# i-STAT ALINITY

## PRODUCT UPDATE

### NOVEMBER 2022 SOFTWARE RELEASE NOTES

#### MANDATORY SOFTWARE UPDATE

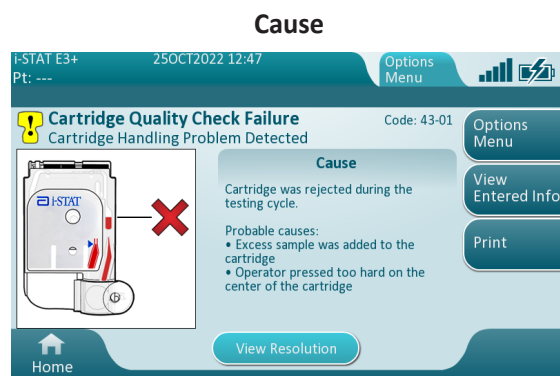
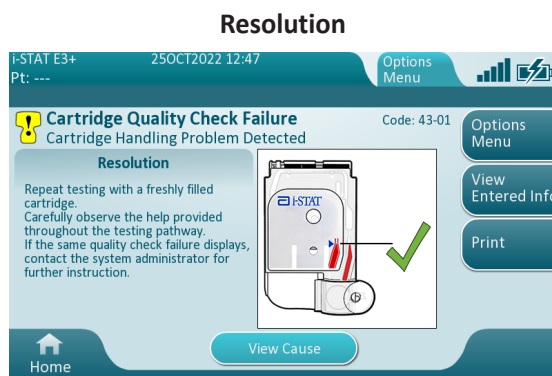
- New Quality Check Failure Code 43 was added to Section 1.2 (i-STAT Alinity Instrument) of the System Operations Manual. Refer to the sample figures below to see Quality Check Failure Code 43 presentation, causes and resolutions.

Note: The cartridge type displayed will be dependent on the cartridge inserted.

#### Cause:

Cartridge was rejected during the testing cycle.

Probable causes:

- Excess sample was added to the cartridge
- Operator pressed too hard on the center of the cartridge

#### Resolution:

Repeat testing with a freshly filled cartridge.

Carefully observe the help provided throughout the testing pathway.

If the same quality check failure displays, contact the system administrator for further instruction.
